Service Bulletin - June 2023

SAF Tire Pilot Plus™ (TPP) Inflation System

Tire Pilot Plus Safety Concern

Figure 4

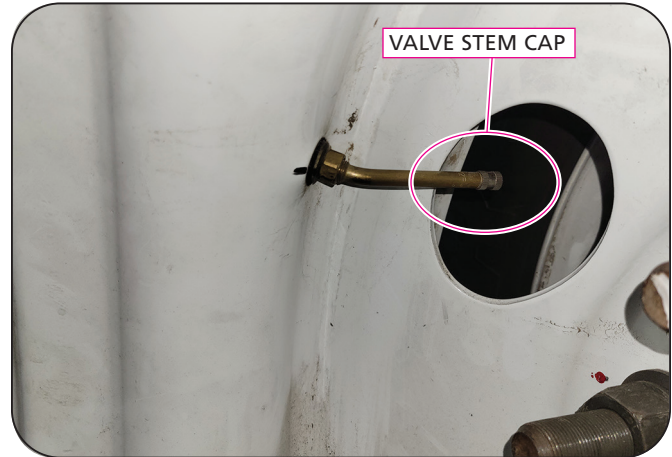
1. If determined to have an electronic regulator assembly, isolate the trailer air tank from its air supply. Drain the air from the trailer air tank.
2. Loosen and remove the tire hoses by hand starting at the hubcap fitting (**Figure 2**). Tire hoses should be disposed.
3. Remove the tire hose fitting from the hubcap using a 15mm or 9/16" deep well socket. (**Figure 3**).
4. Install a valve stem cap on the tire valve stem (**Figure 4**).
5. Install the 1/4 NPT pipe plug in the hubcaps. Install hand tight plus 2 turns or 25-30 lb-in (**Figure 5**).
6. Disconnect the air line from the PPV as illustrated (**Figure 6**).
